Application No.: 10/765,313

Response dated: September 14, 2005

Reply to Office Action dated: June 14, 2005

AMENDMENTS TO THE DRAWINGS

Figure 3
(Prior Art)

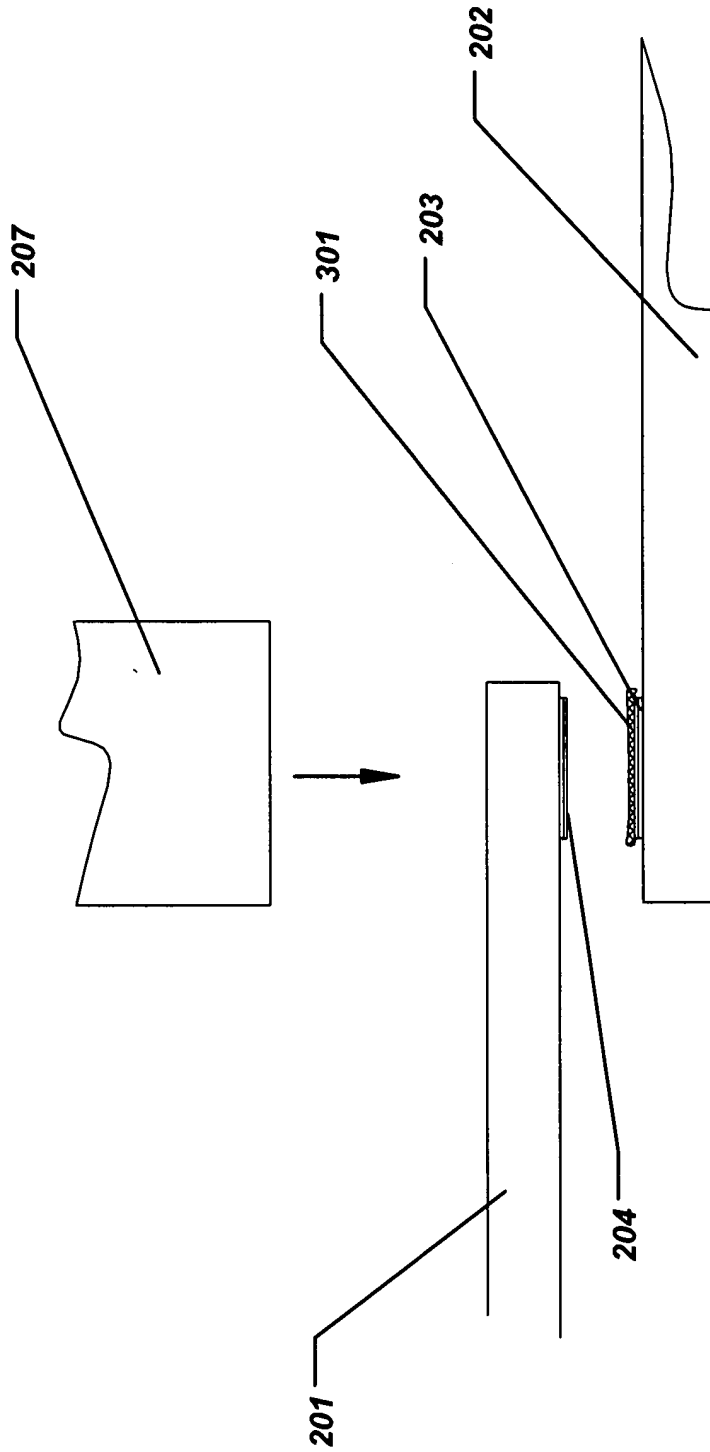
The attached sheets of drawings include changes to Figures 2 and 3 designating prior art.

The Office Action objected to the drawings. The drawings have been amended per the Examiner's instructions.
